**THE AIRPLANE FACTORY (Pty) Ltd**, Registration no 2002/022837/07  
Hangar 8 Tedderfield Airpark, Nettleton Road, Eikenhof, 1872, Johannesburg South  
PO Box 308, Eikenhof, 1872, South Africa. Tel: +27 (0)11 948 9898 Fax: +27(0)86 632 4493  
E-mail: sales@airplanefactory.co.za Web: www.airplanefactory.co.za

**NOTIFICATION**

**#0002**

Wires overheating on Rotax 912 iS B-side voltage regulators

Discolored Wires

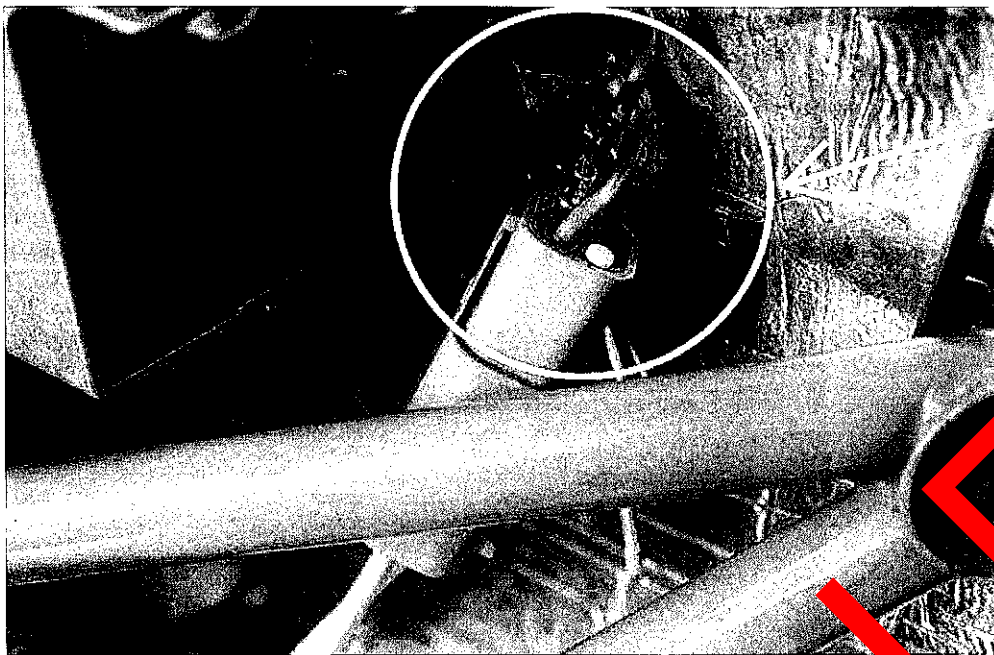
Before each flight the condition of the yellow wires running to the B-voltage regulator must be checked for discoloration. This can be done through the left-hand inspection door on the top engine cowling. (See attached photographs), with the exception of the following aircraft serial numbers:

In the photograph below the discoloration is evident. Note the brown color of the brittle overheated wires.

Should melted wires be noticed it is recommended that the aircraft not be flown and The Airplane Factory, TAF distribute for the nearest Rotax Service Centre be contacted for assistance.

Standard Color  
Wires

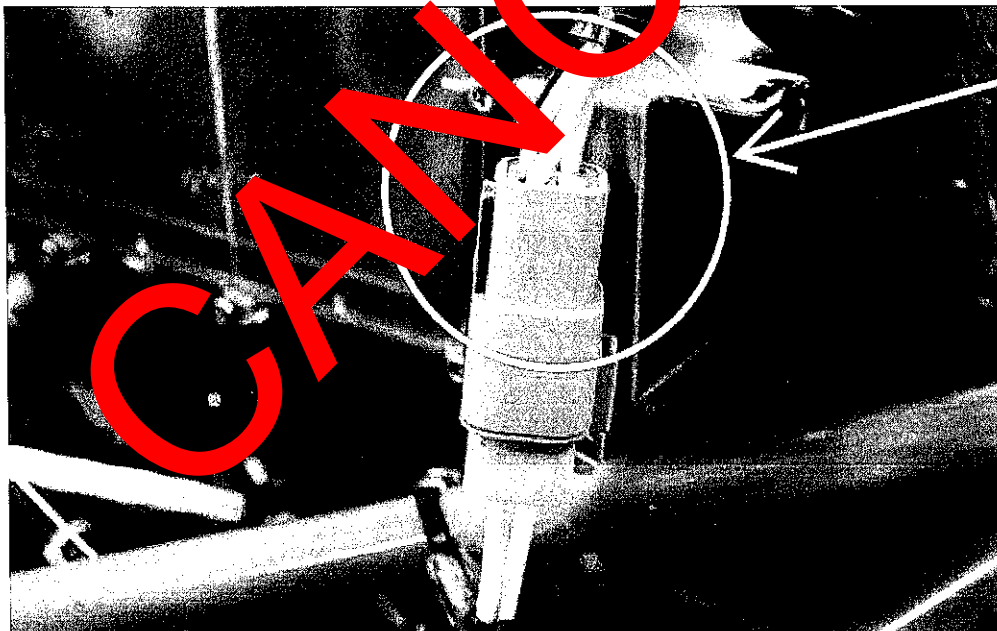
The photograph below indicates a normal voltage regulator connector plug.
